**Niagara Region Wind Farm
Renewable Energy Approval
Amendment
Modification Report**

File No. 160950269
October 5 2015

NIAGARA REGON WIND FARM - RENEWABLE ENERGY APPROVAL AMENDMENT MODIFICATION REPORT

**Records Review -
Natural Features
Figure 2.20
Revised**

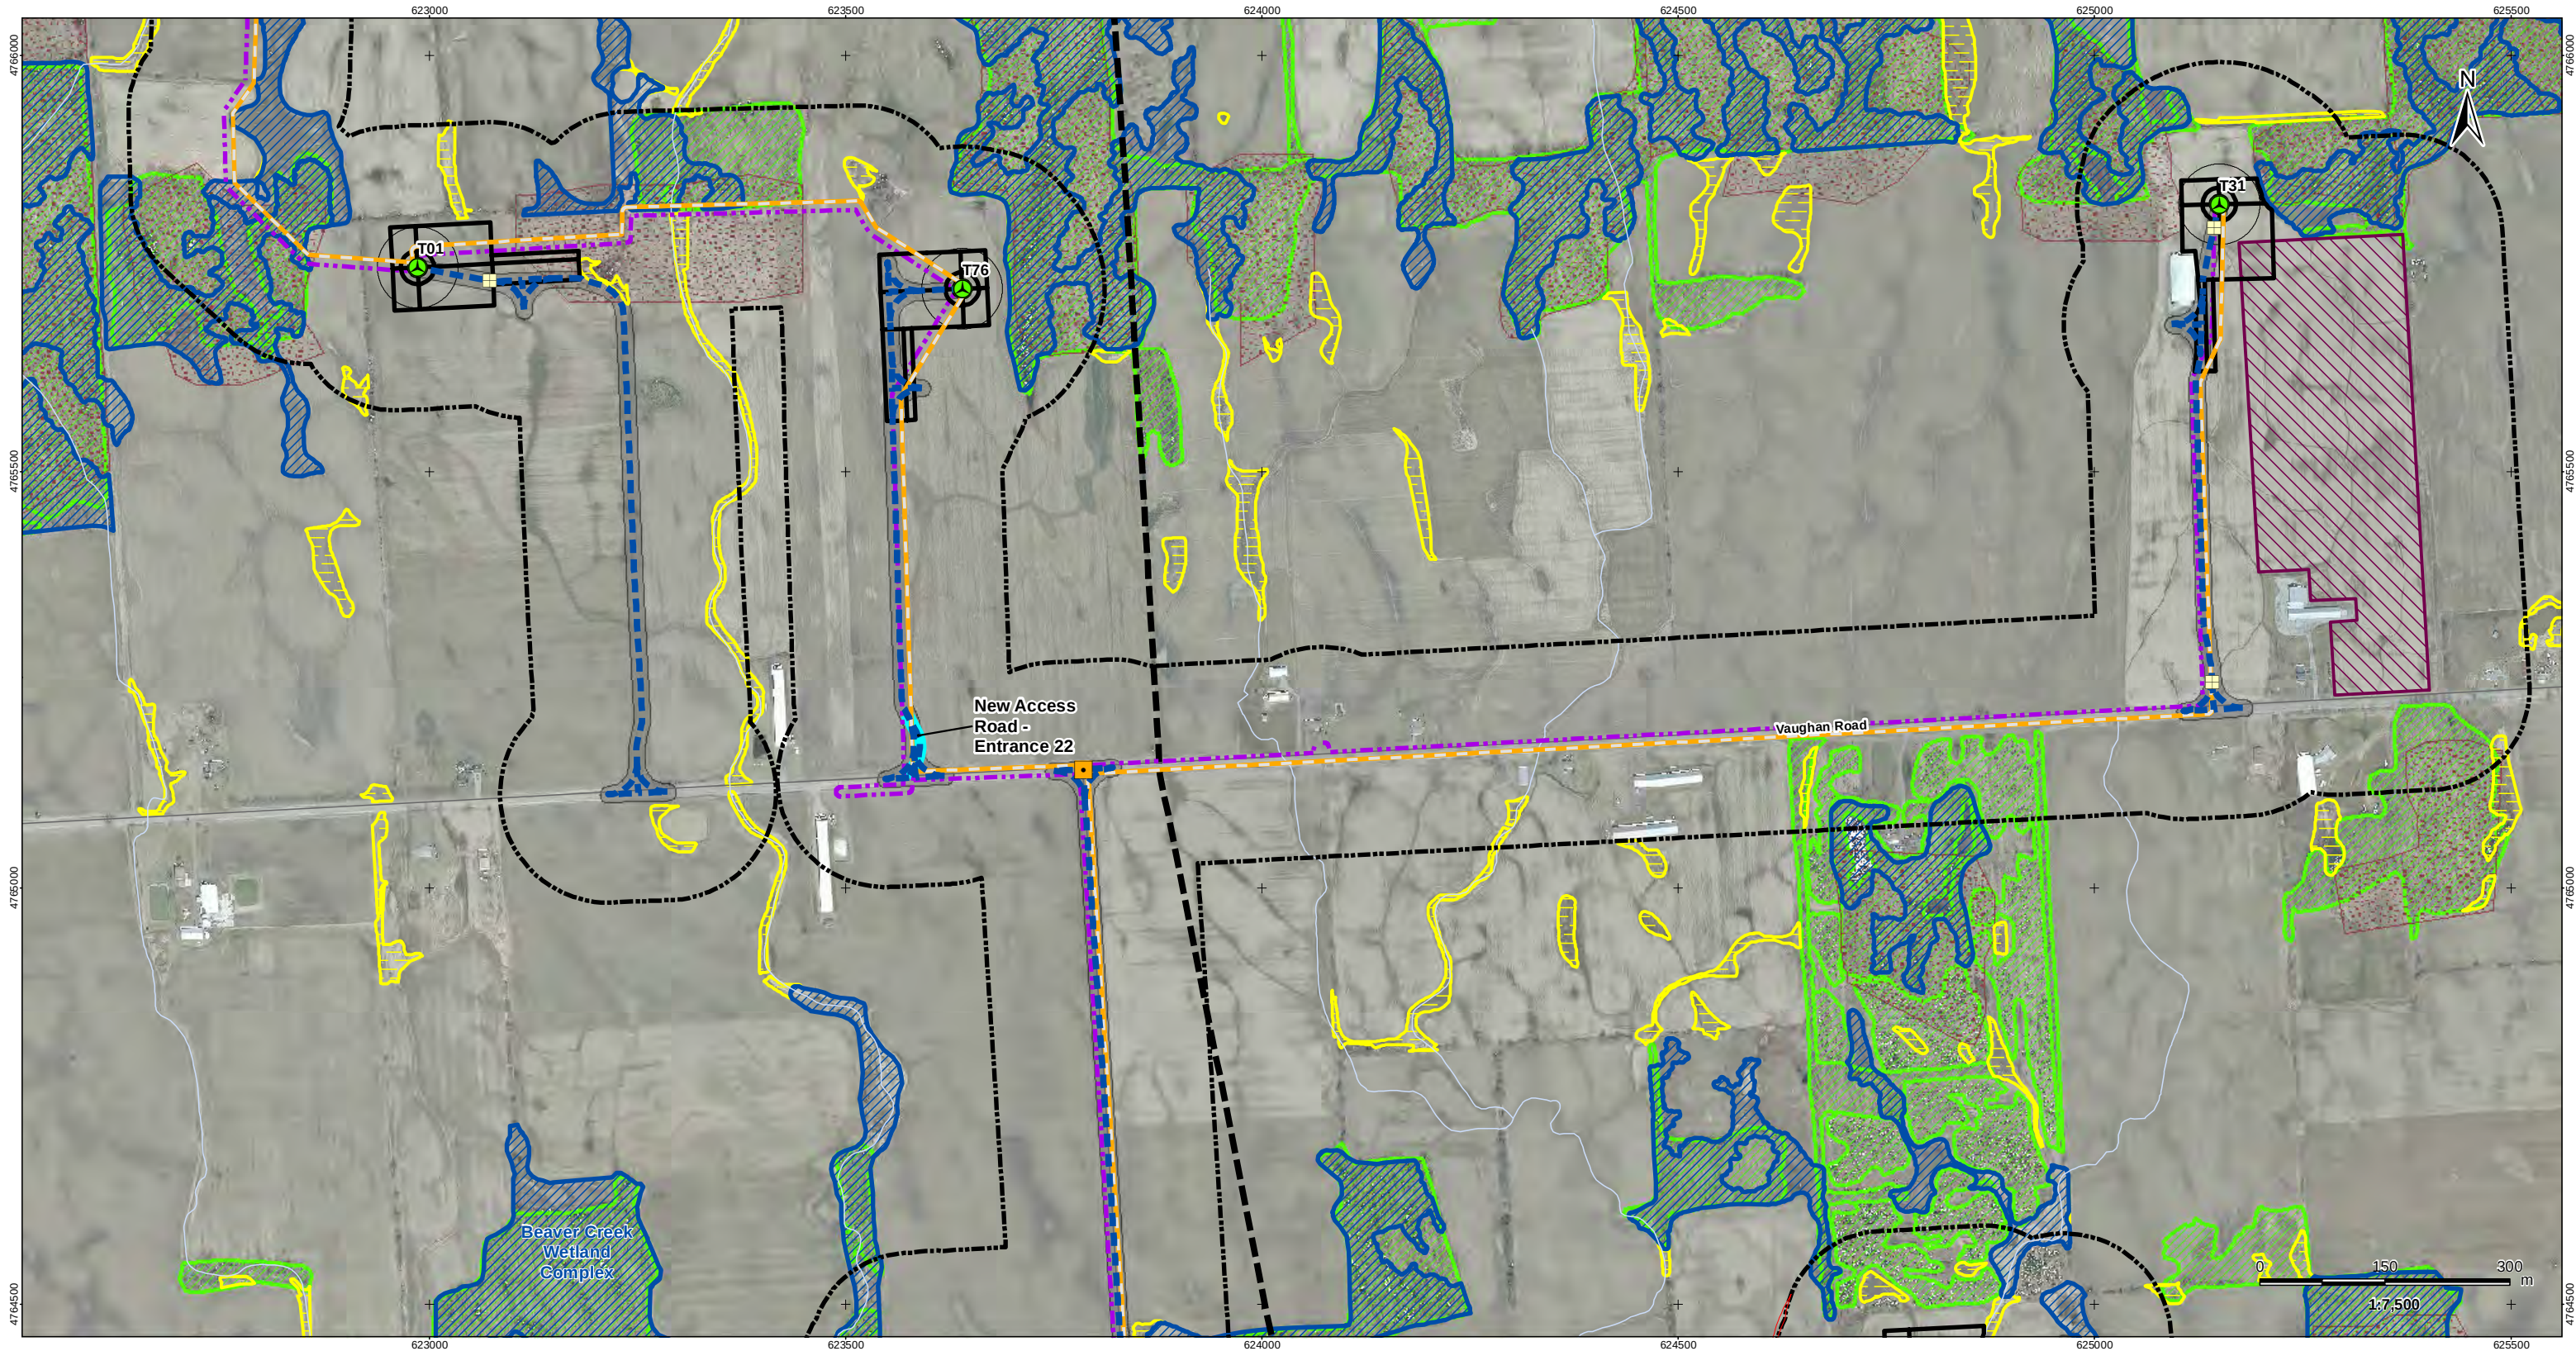
ADDITIONAL REPORTS			
Natural Heritage Assessment Report	Yes	1, 2.1, 2.20, 2.28, 2.31, 2.35, 2.39, 2.41, 2.43, 2.48, 2.54; 3.1, 3.20, 3.28, 3.35, 3.39, 3.41, 3.43, 3.48, 3.54; 4.1, 4.20, 4.28, 4.35, 4.39, 4.41, 4.43, 4.48, 4.54; 5.1, 5.20, 5.28, 5.35, 5.39, 5.41, 5.43, 5.48, 5.54; 6.1, 6.20, 6.28, 6.35, 6.39, 6.41, 6.43, 6.48, 6.54; 7.1, 7.20, 7.28, 7.35, 7.39, 7.41, 7.43, 7.48, 7.54	Figures to be updated to display the revised Footprint of Interconnect Station, Alternate Access Road from T11 to T12 to T41, Footprint of North Substation, and revised Access Road Entrances, Appendix A (Modification A, B, C, D, and G). Executive Summary: a) update text to a rated capacity ranging from 2.9MW to 3.0MW, 90 MVA base rating for north transformer and 69 MVA for the south transformer. Section 1.1: (a) update text to a rated capacity ranging from 2.9MW to 3.0MW, 90 MVA base rating for north transformer and 69 MVA for the south transformer. Approved NHA/EIS was completed assuming a rotor diameter of 101 m at all turbine locations, including those previously approved as E82 turbines. No change in turbine location required. See Appendix B for a copy of the Natural Heritage Assessment Addendum.
